Parish Hall Package B
Our Lady of Victory - Diocese of Victoria
Project # 716-0114 B

ADDENDUM NUMBER TWO

April 29, 2016

RMA Rawley McCoy & Associates, PLLC ARCHITECTS AND INTERIOR DESIGNERS	SHEET TITLE:	FLOOR PLAN - LEVEL 1 NORTH	REVISION TYPE:	ADDENDUM 2
	DATE:	04/29/16	SHEET NO.:	BA1.1R1
	SCALE:	1/8" = 1'-0"	PROJECT #:	716-0114B

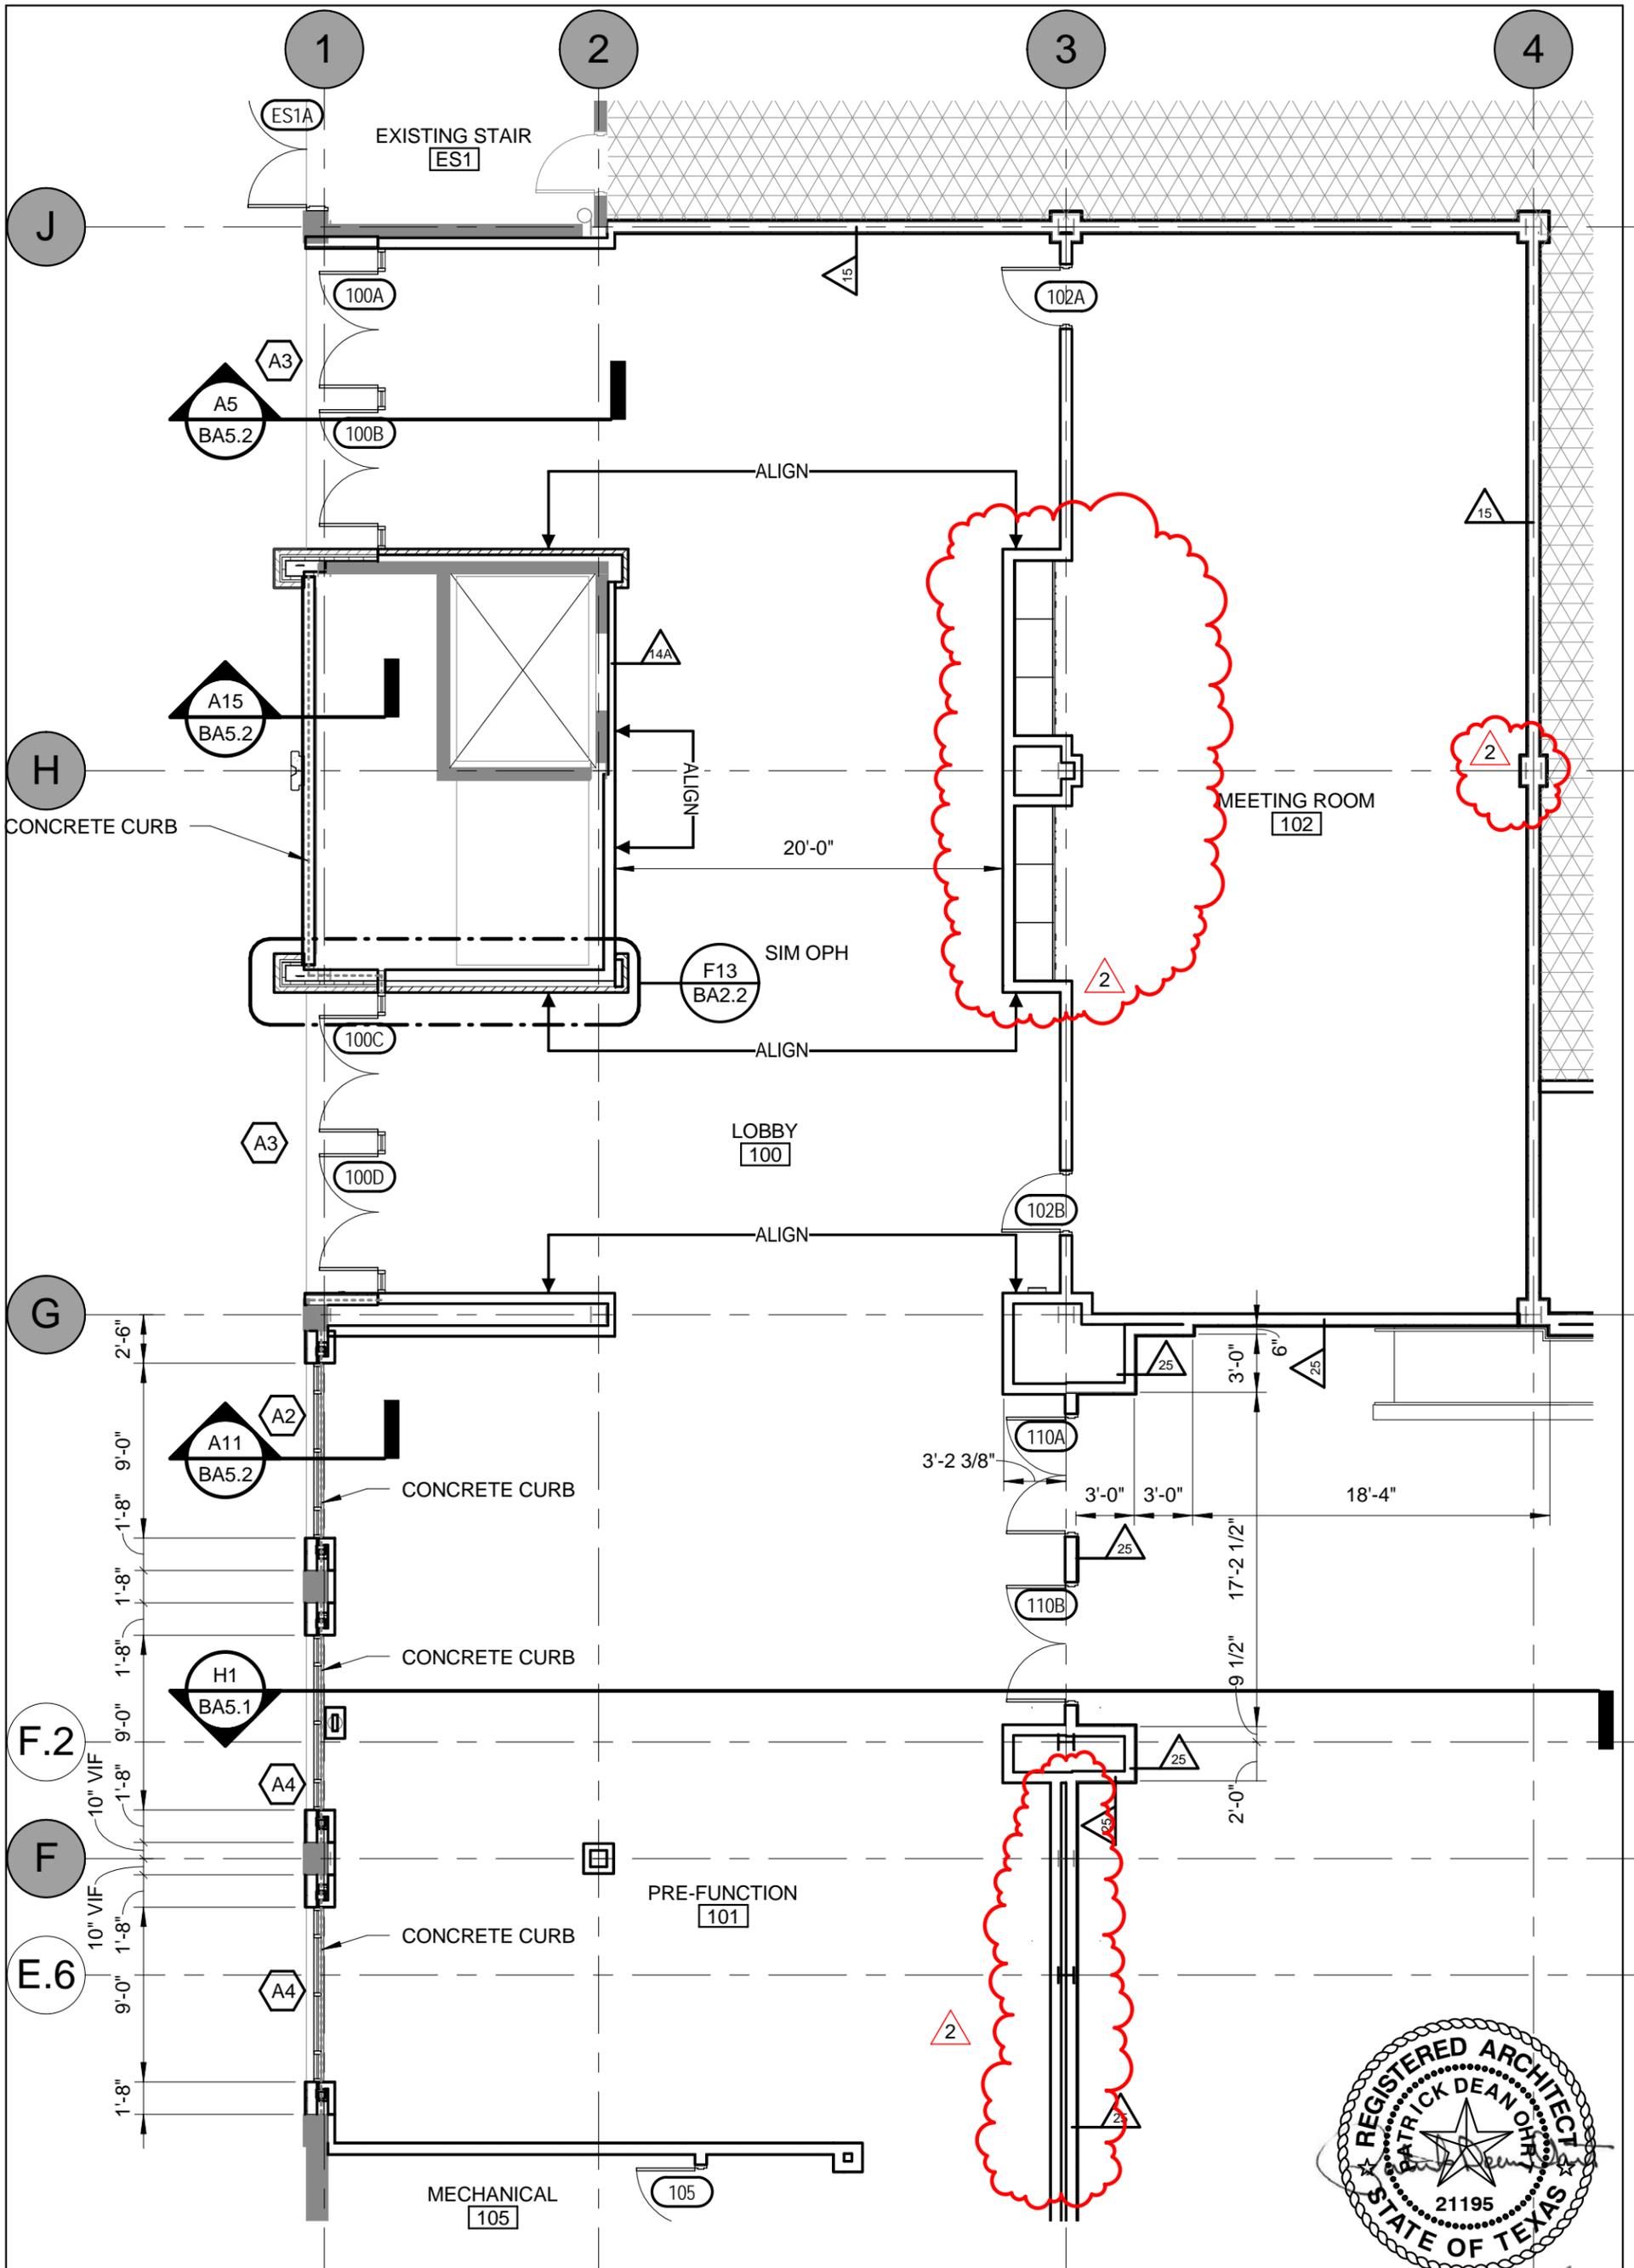
1. BA1.1R1 FLOOR PLAN – LEVEL 1 NORTH
Revision: **SEE ATTACHED**
Revised wall furring
Added casework in Meeting 102

SHEET TITLE:	COUNSELING CENTER FLOOR PLAN	REVISION TYPE:	ADDENDUM 2
DATE:	04/29/16	SHEET NO.:	BA1.2R1
SCALE:	1/8" = 1'-0"	PROJECT #:	716-0114B

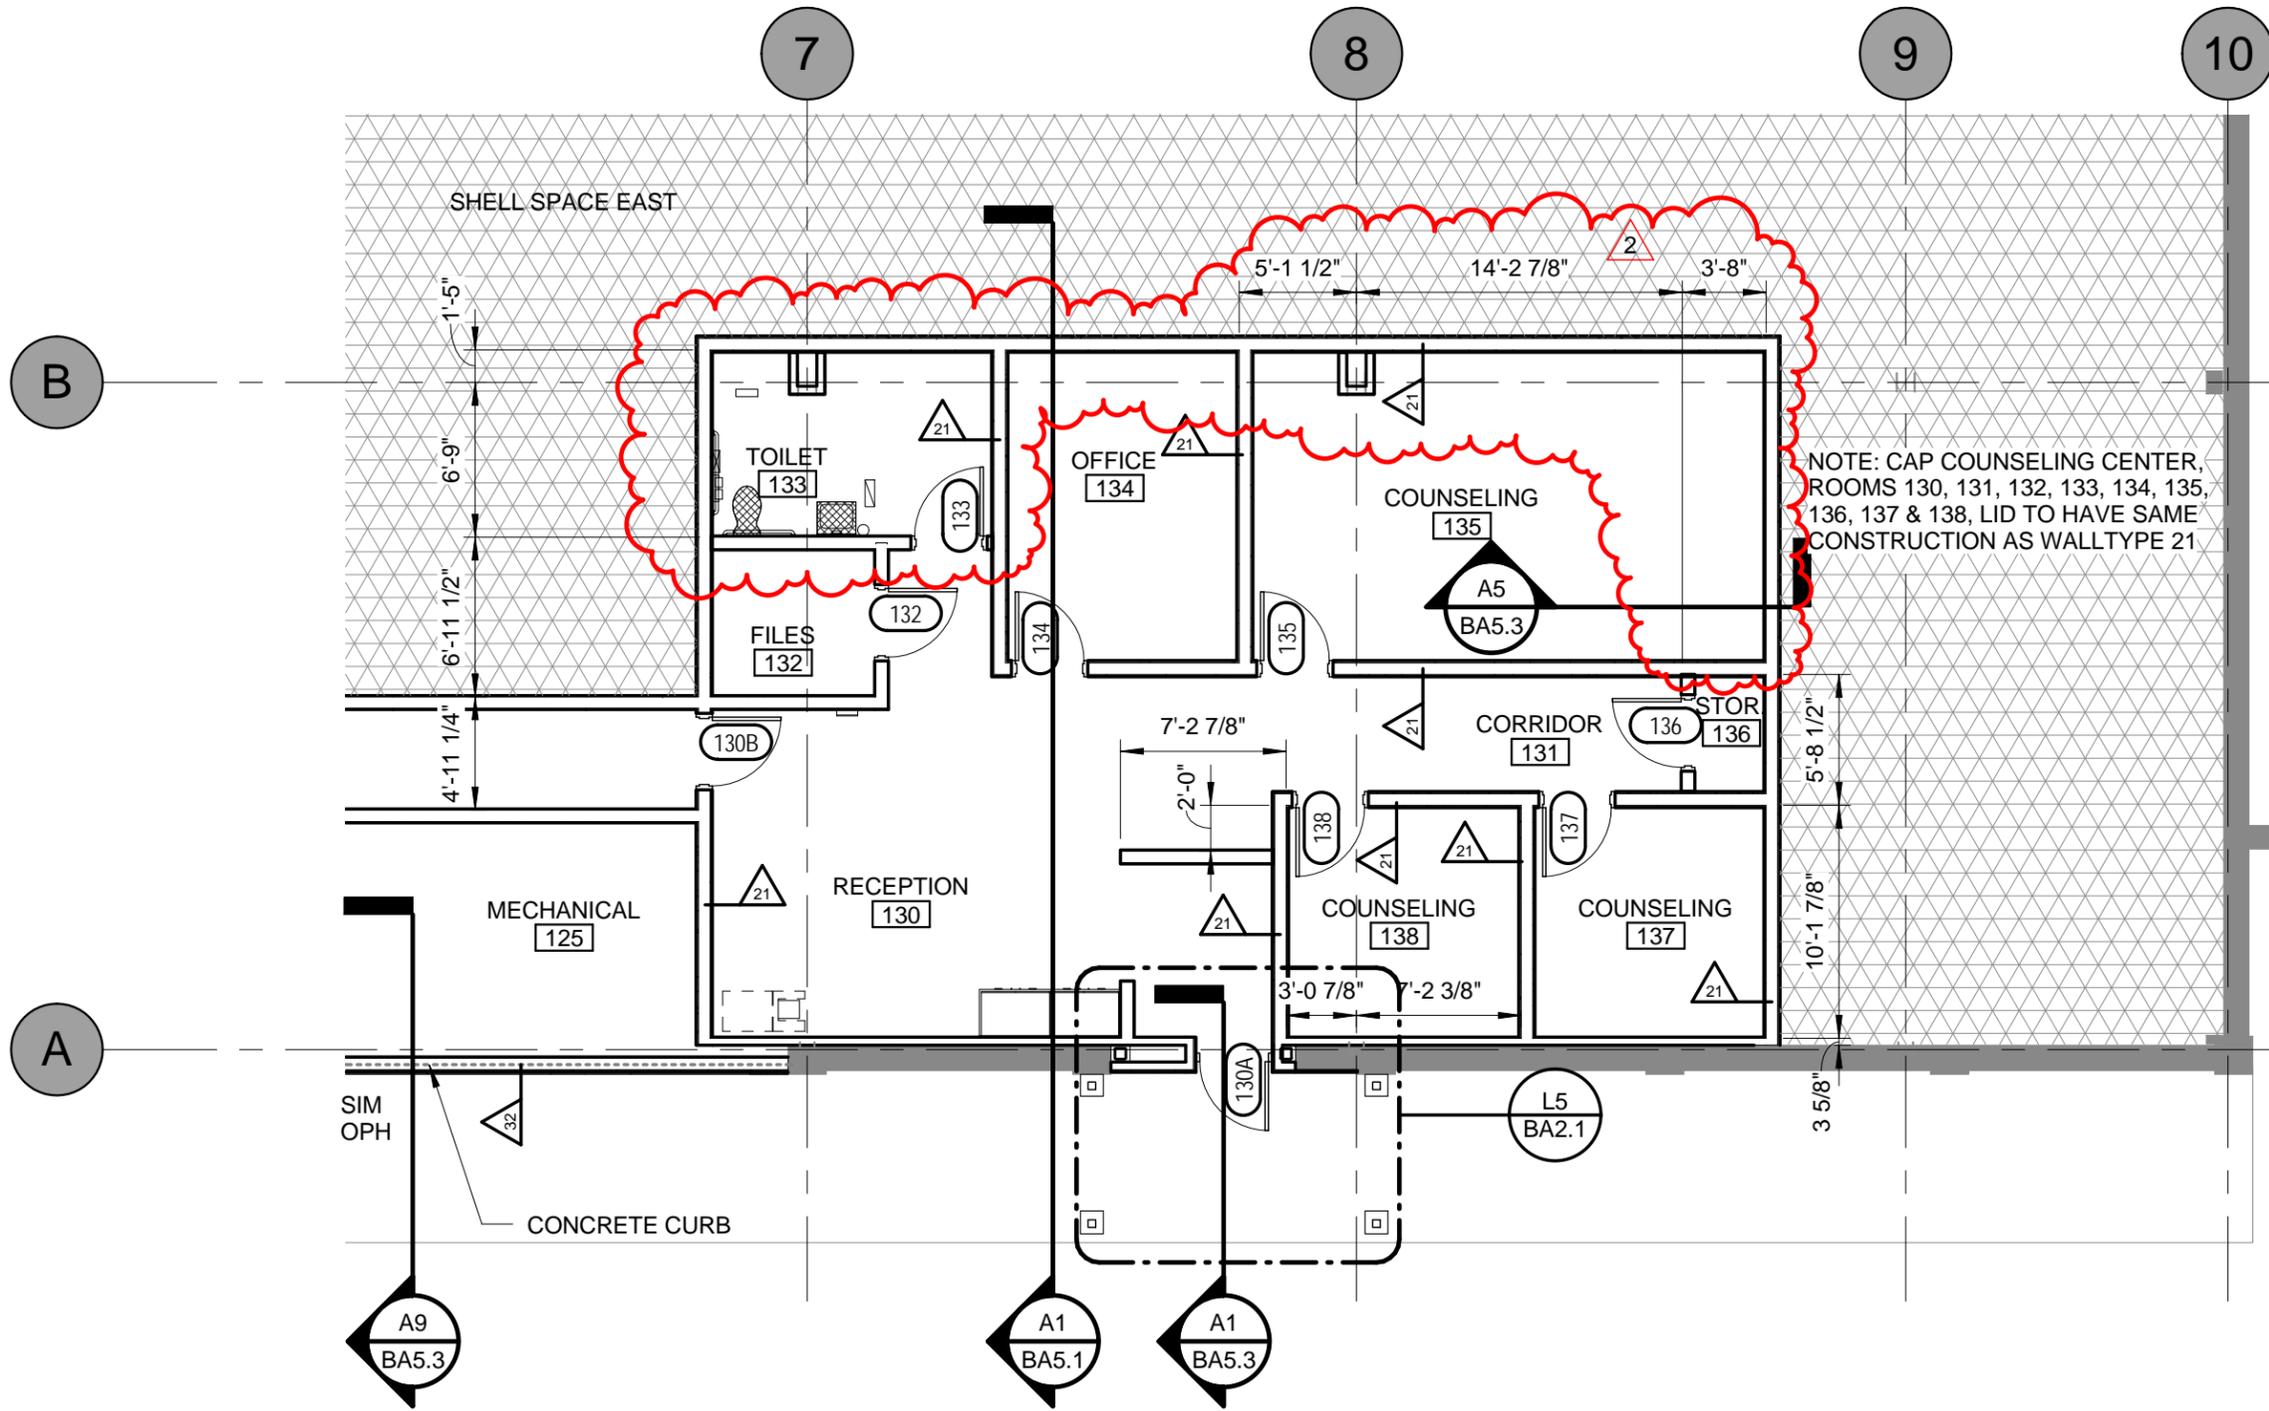
2. BA1.2R1 COUNSELING CENTER FLOOR PLAN
Revision: **SEE ATTACHED**
Revised wall location
Enlarged rooms 133, 134 and 135

NOTE: CAP COUNSELING CENTER, ROOMS 130, 131, 132, 133, 134, 135, 136, 137 & 138, LID TO HAVE SAME CONSTRUCTION AS WALLTYPE 21

<p>PARISH HALL Our Lady of Victory Catholic Church - Diocese of Victoria</p>		
 Rawley McCoy & Associates, PLLC ARCHITECTS AND INTERIOR DESIGNERS	SHEET TITLE: COUNSELING CENTER ENLARGED PLAN	REVISION TYPE: ADDENDUM 2
	DATE: 04/29/16	SHEET NO: BA2.1R1
	SCALE: 1/4" = 1'-0"	
	PROJECT #: 716-0114B

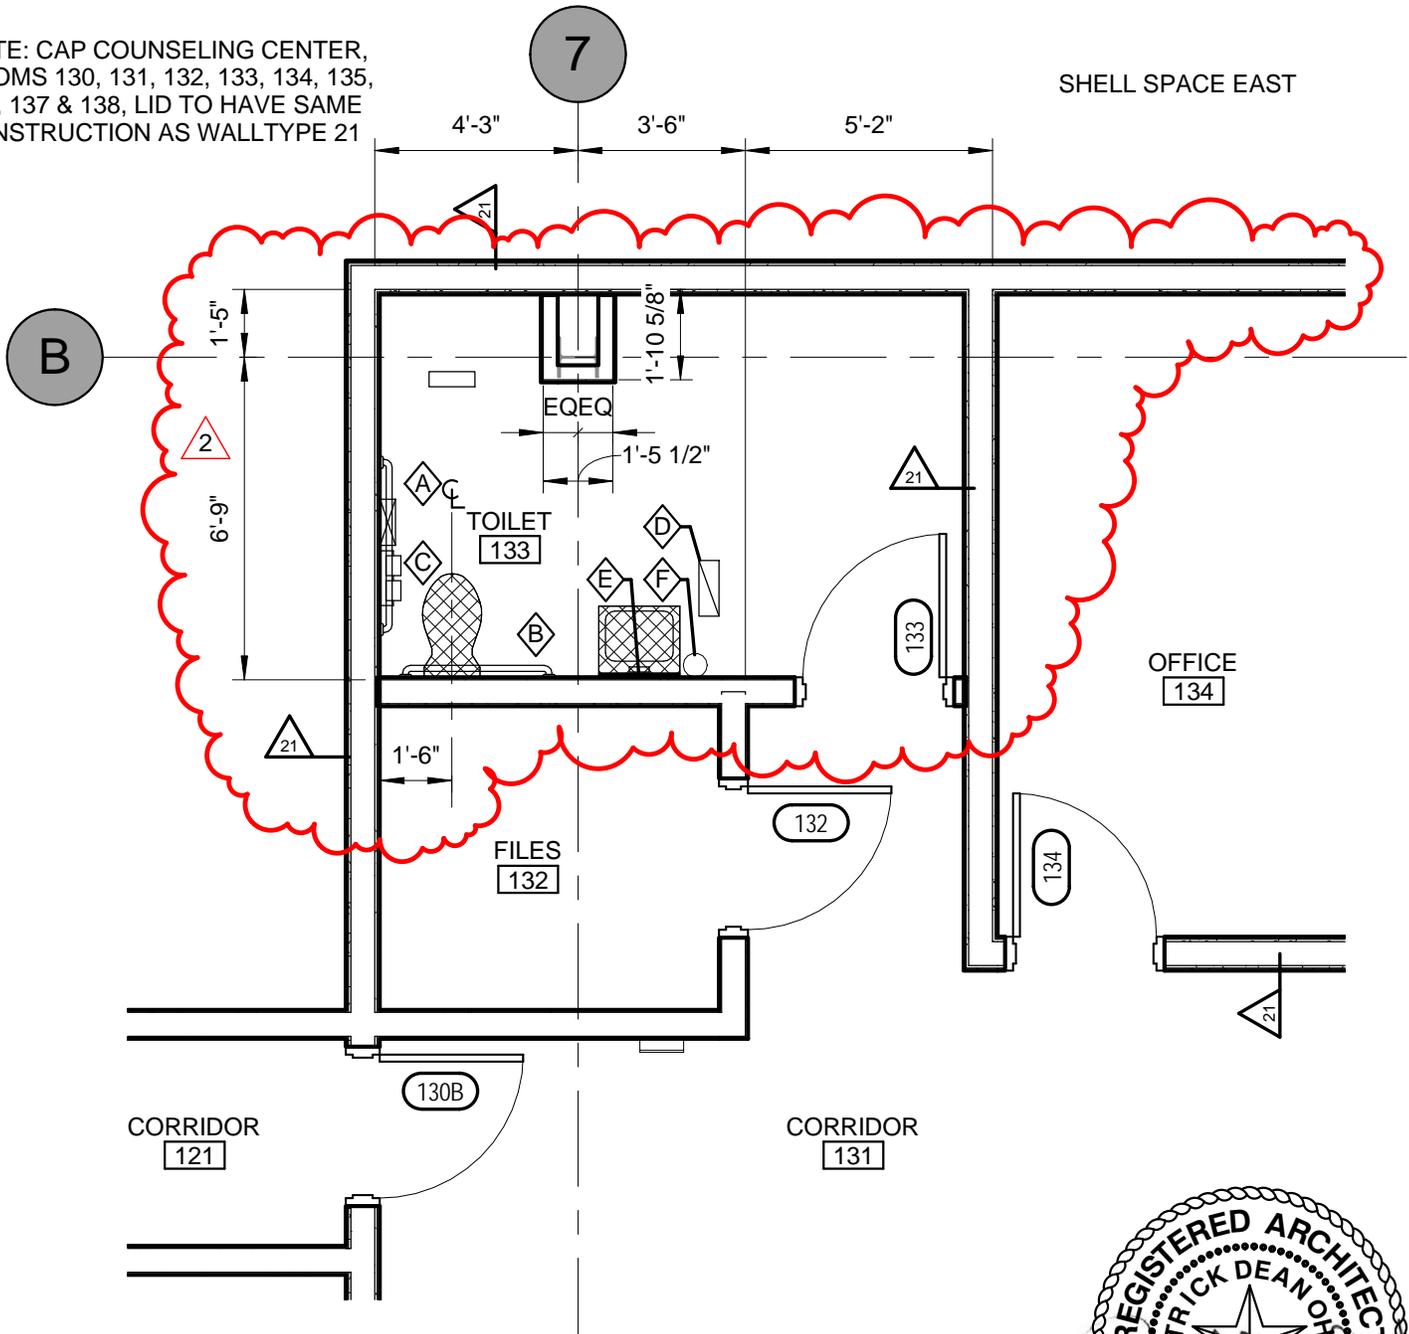
3. BA2.1R1 COUNSELING CENTER ENLARGED FLOOR PLAN
Revision: **SEE ATTACHED**
Revised wall location
Enlarged rooms 133, 134 and 135
